BID ADDENDUM #3

DATE: June 5th, 2023
PROJECT: 15th Street Extension
PROJECT P.I. NO. 0015019
NUMBER:

REVISION SUMMARY
15TH STREET EXTENSION

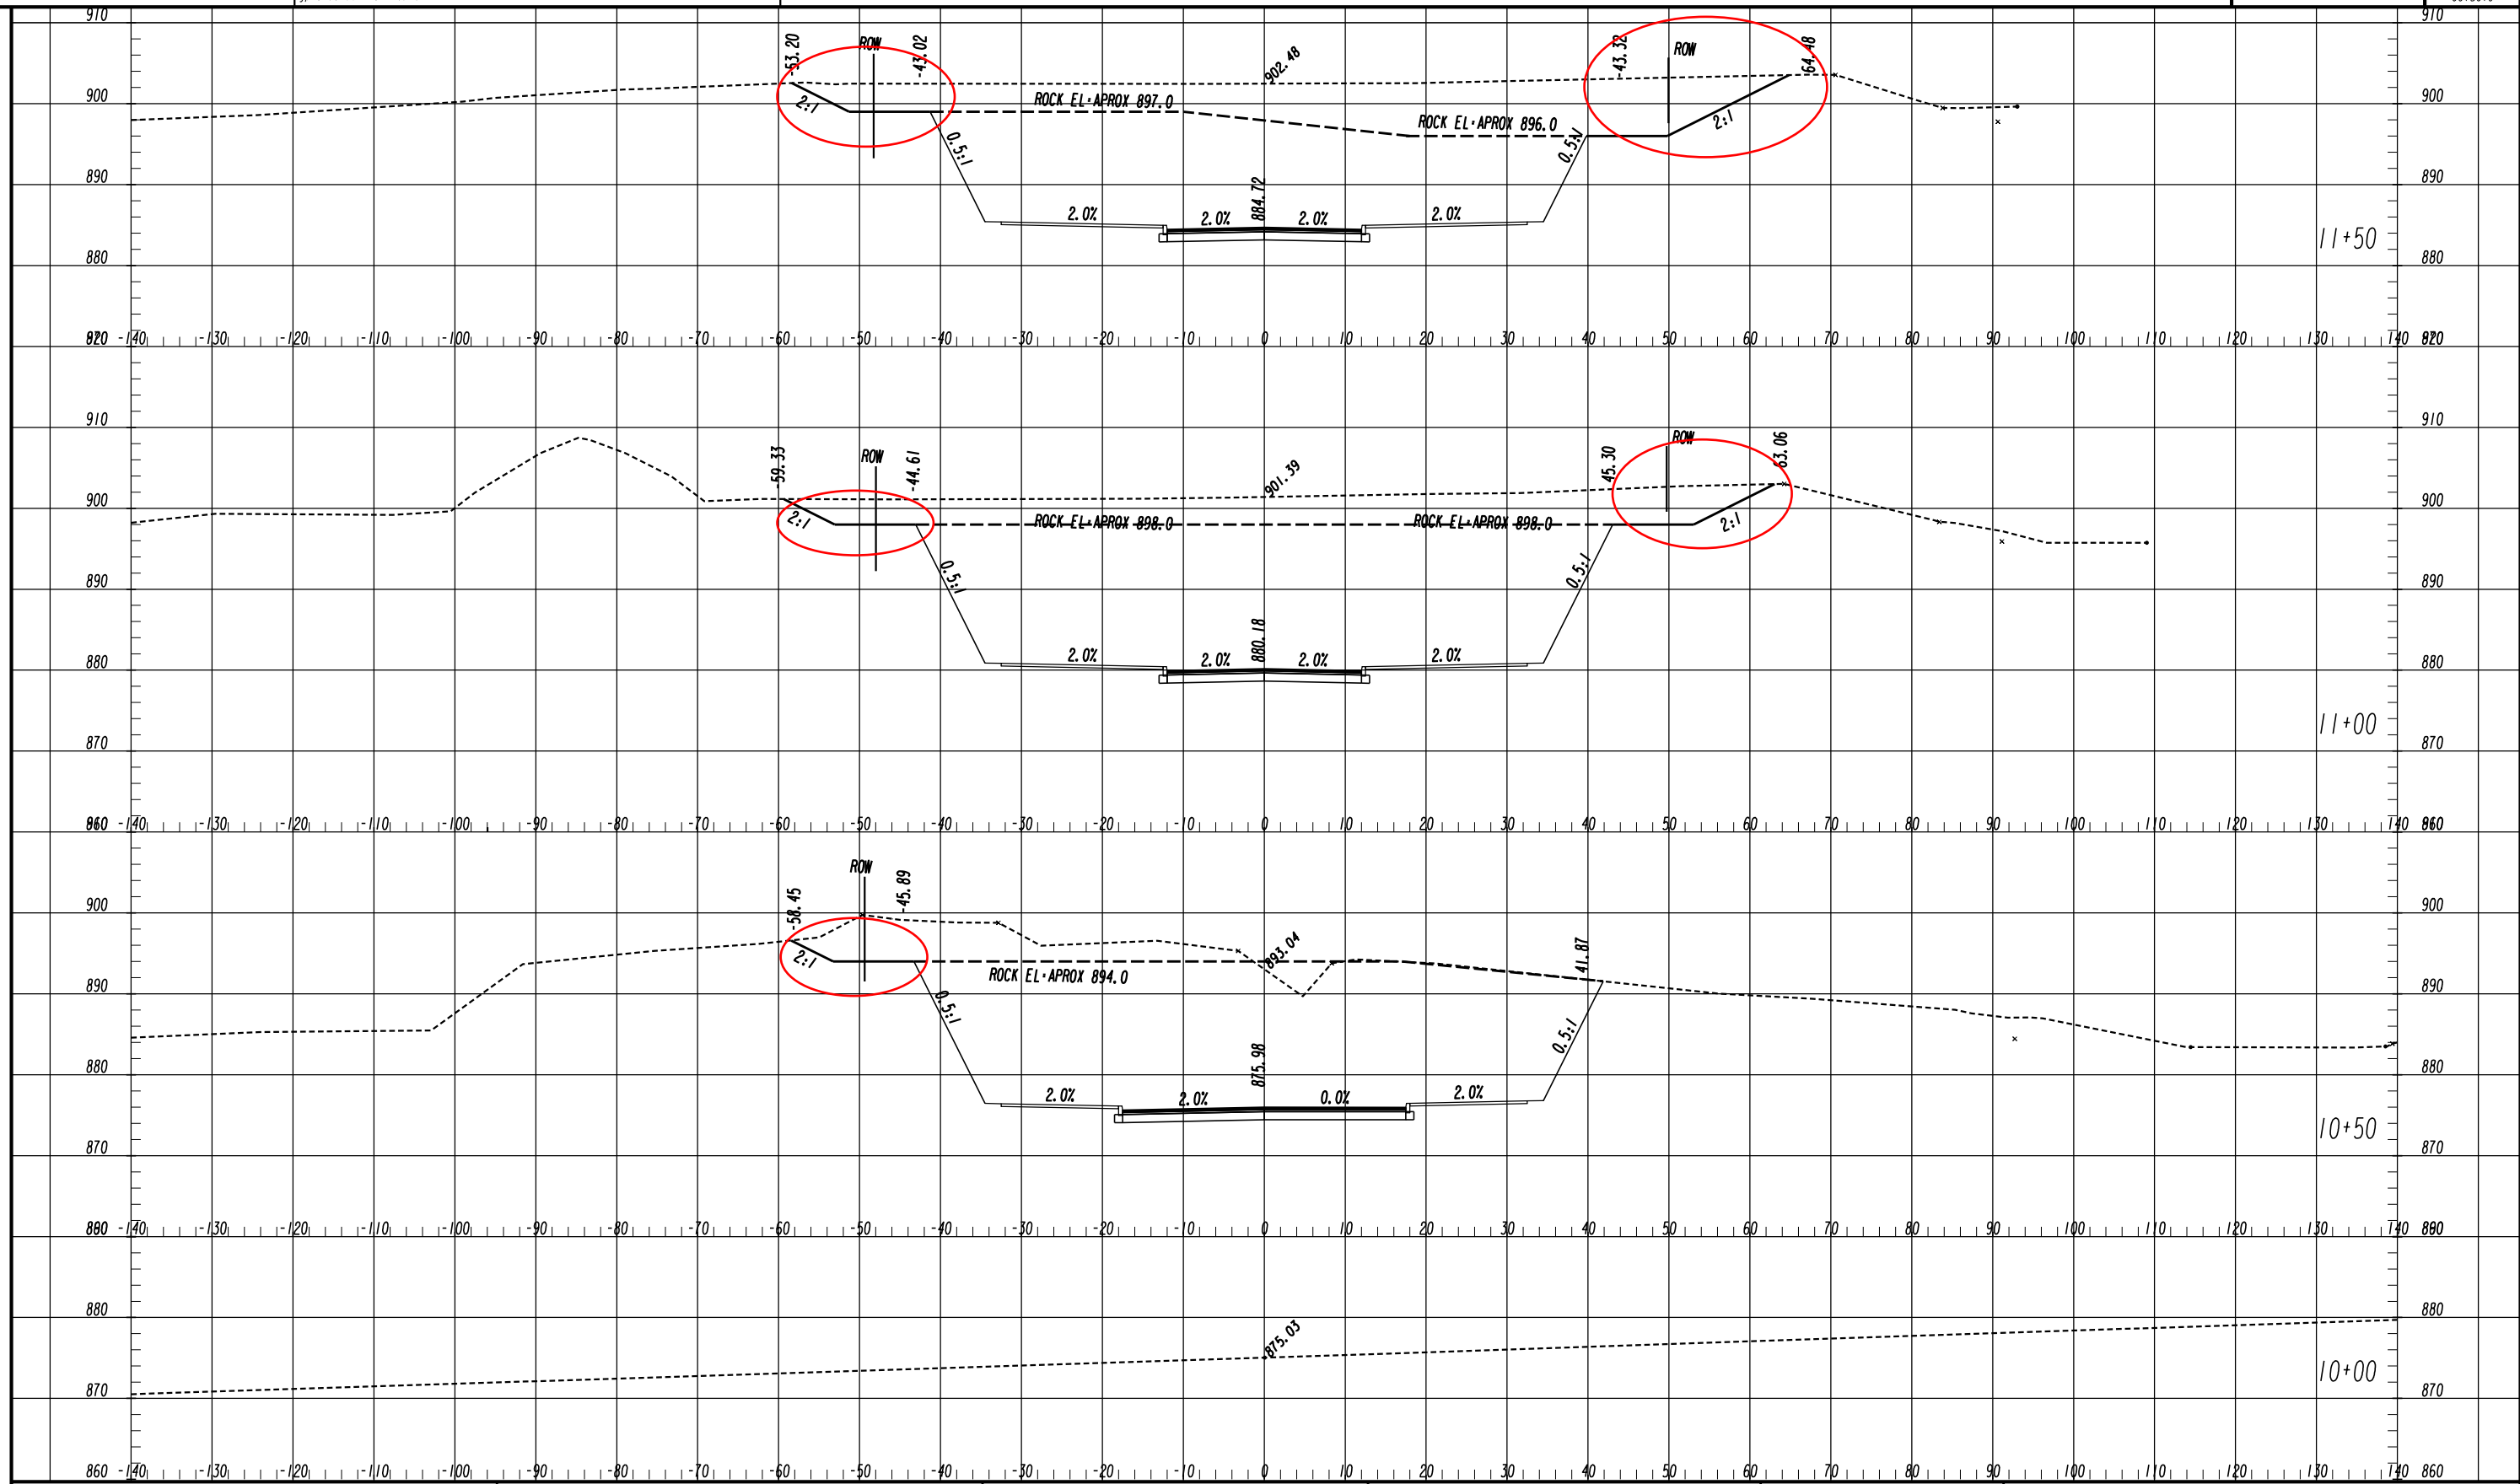
2. **Question:** From stations 10+50 to 13+00 the cross sections show a 0.5:1 front slope through continuous rock all the way to the limits of construction. The soil survey at station 12+00 Right (Figure 2-2, page 9) suggests the depth of rock is approximately 5 feet with 9 feet of backfilled material on top. The Detail for Rock Cut (Figure 3, page 10) shows a required 10 foot bench and using 2:1 when placing a soil embankment at on top of cut rock. There is not enough room between the limits of construction and the right of way to accommodate the additional width created from transitioning from 0.5:1 to a 2:1 let alone a 10 foot bench. Please clarify how the Contractor is to construct this section of proposed roadway.

| DATE | DRAWING NO. | REVISION |
|------------|-------------|--|
| | 23-0001 | ADDED 10 FT BERM AND UPDATE THE CONSTRUCTION LIMITS. |

Answer: Cross sections will be revised to show the 10-foot bench per the soil survey report. Permanent easements will be added to the plans to accommodate the revised construction limits. Revised plan sheets are provided within Addendum No. 3.

| CORRECTED: | DATE: | 23-0002 |

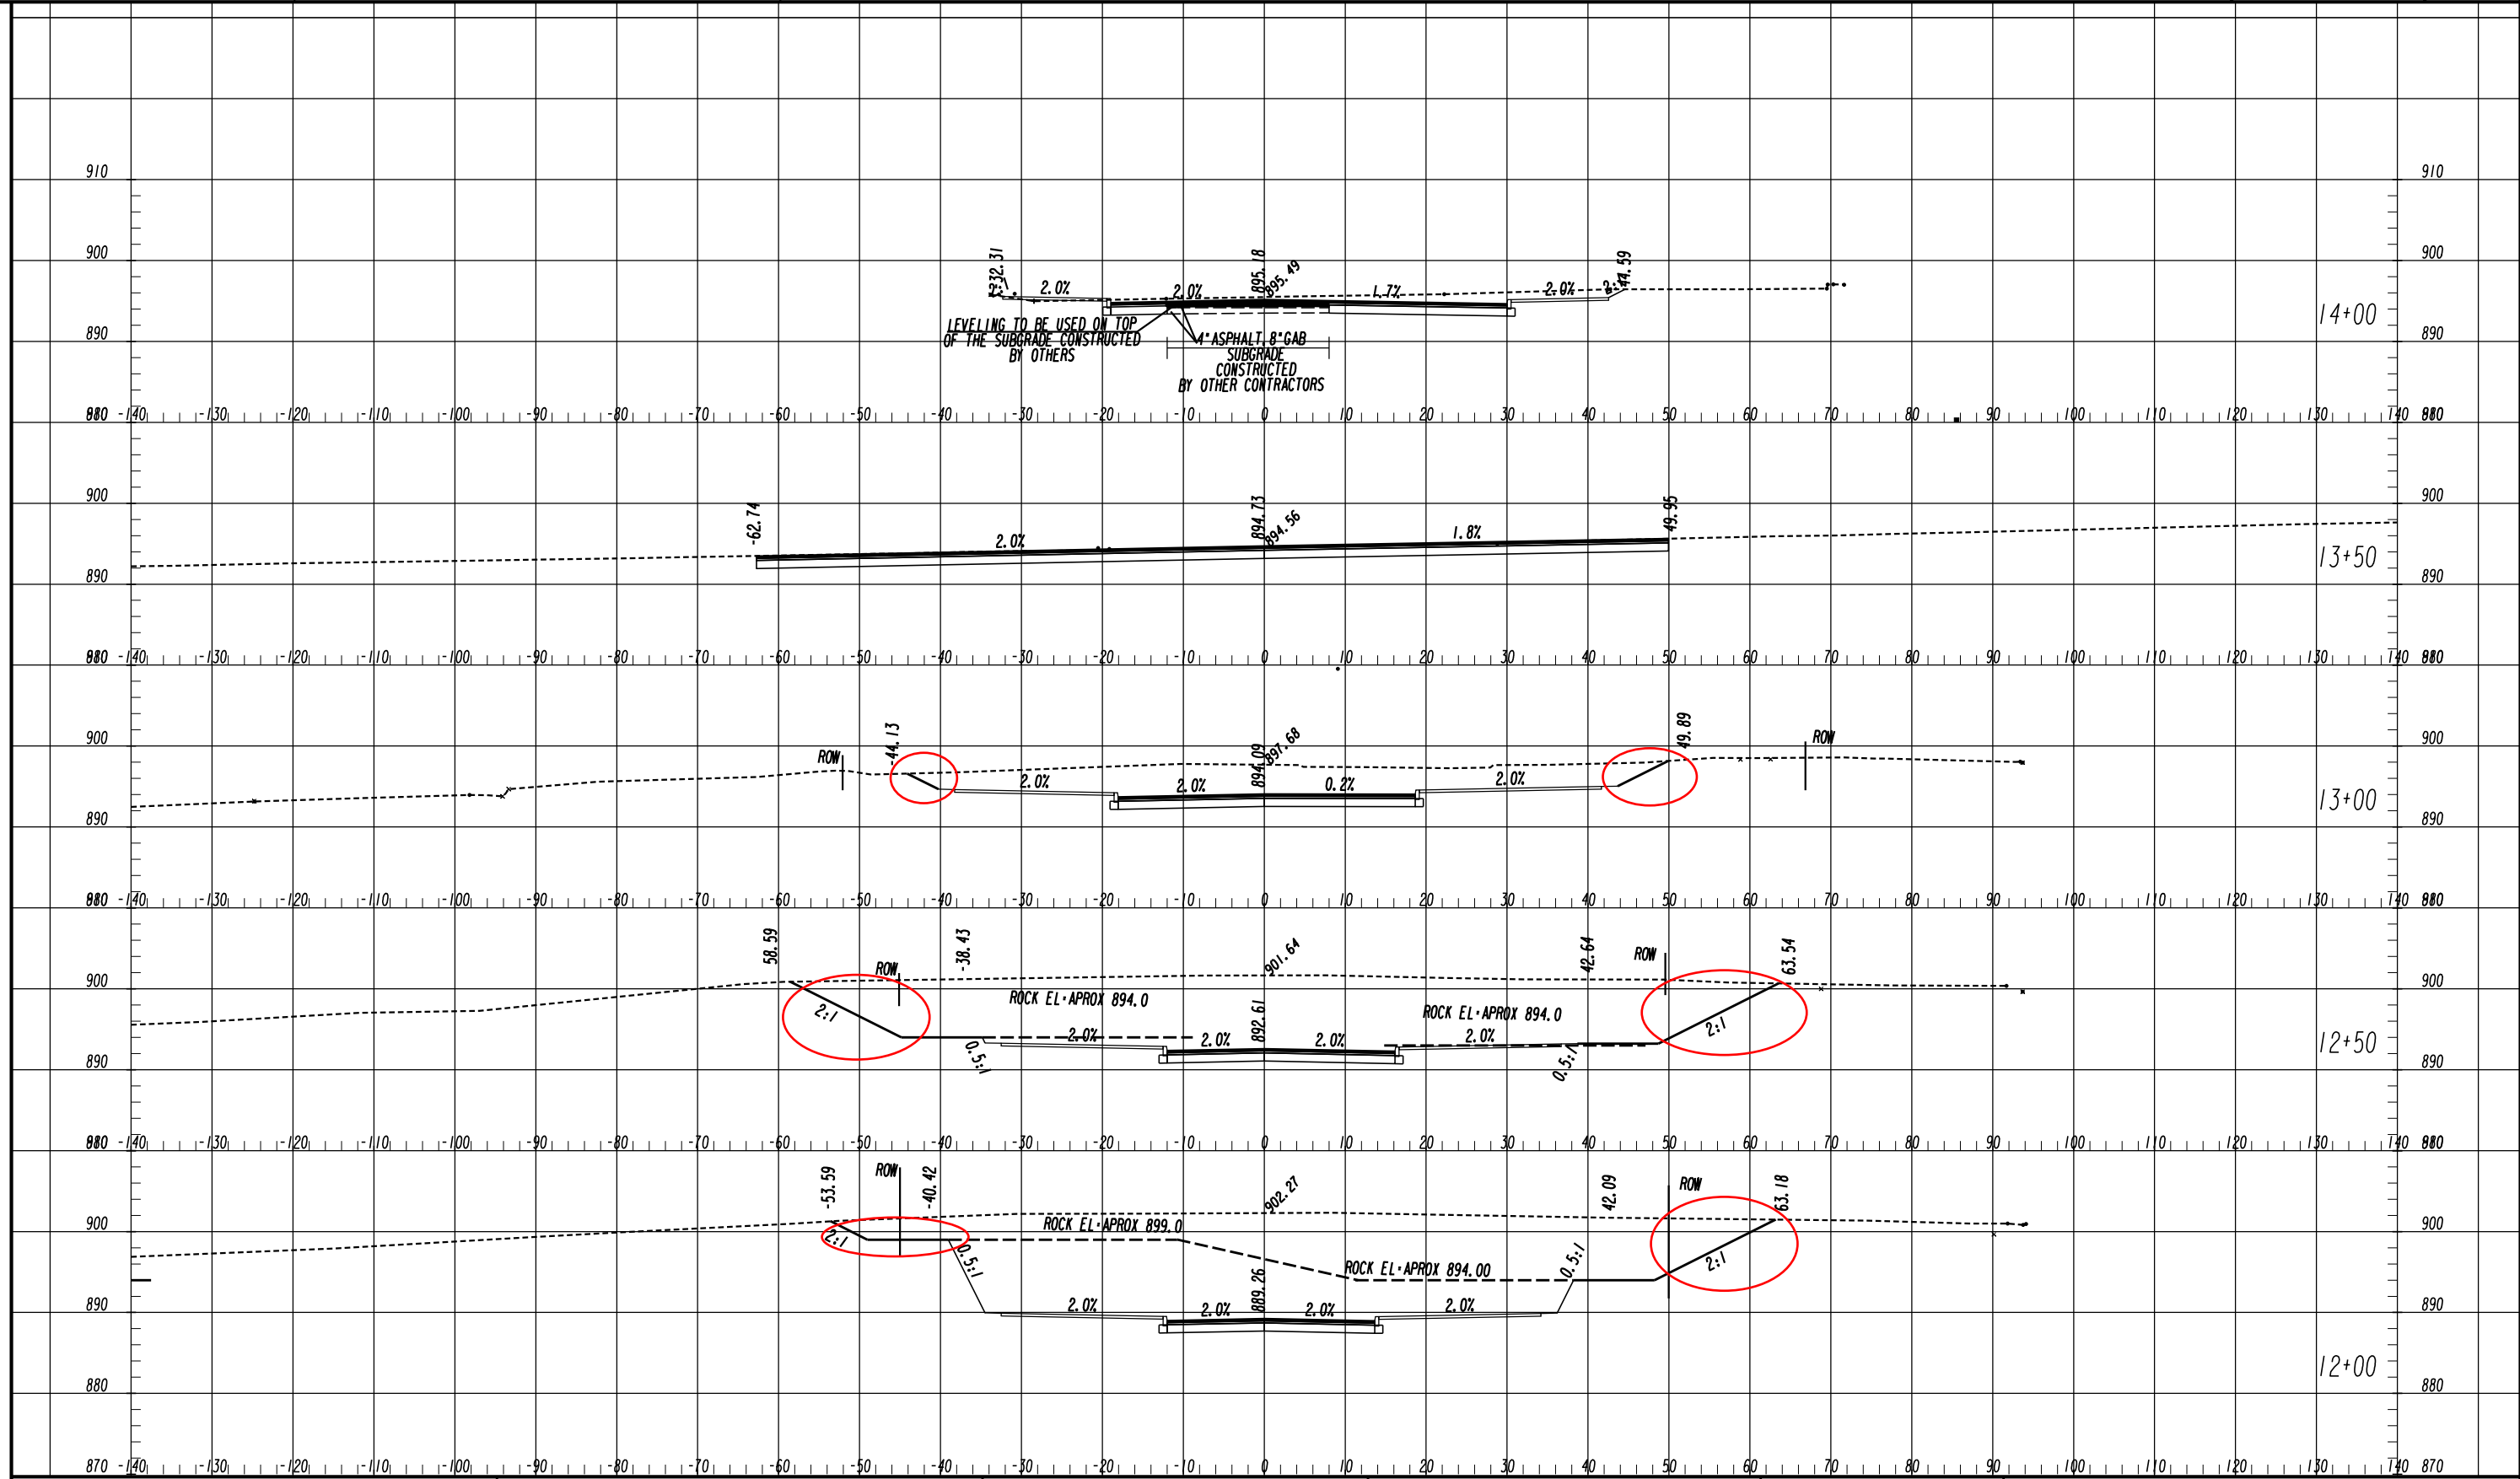
| DATE | DRAWING NO. | REVISION |
|------------|-------------|--|
| | 23-0002 | ADDED 10 FT BERM AND UPDATE THE CONSTRUCTION LIMITS. |
